2015/4373/P 13 Kemplay Road

I wish to object to this application for the following reasons:

Photos 1 & 2: Corner of lane to Rosslyn Chapel & 13 Kemplay Rd, front

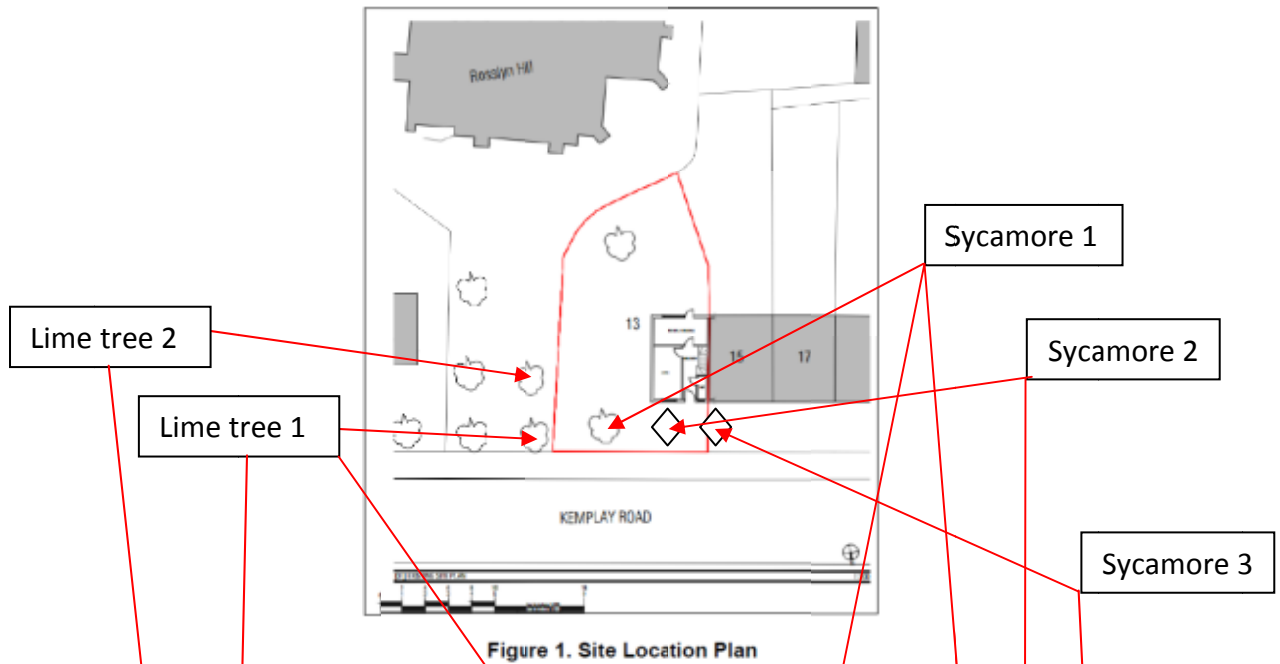
1) No tree plan or arboricultural report has been submitted. There is no reference to trees in the application or on the existing and proposed plans. Using the site location plan where a few of the existing trees are shown and others added by me as diamonds, this is compared to photographs taken November 2014 when individual trees can be seen. All trees in the photographs are still standing. The importance of these trees for streetscape amenity can be easily observed. All are to be felled without replacement or will not survive the damage done to them by construction vehicles and excavation as BS5837 (2012) is not being applied.

There is a line of tall sycamores up this side of Denning Road that continues with this line of tall lime trees along each side of the rear entrance road to Rosslyn Hill Chapel to the side of 13 Kemplay Road.

We understand it likely the owner considers them as 'condemned' and as such they require no mention. If these trees are to be condemned for decay, please ensure any permission to remove them includes a section 106 about their replacement with an equal or greater number of tall and similar species trees for the future.
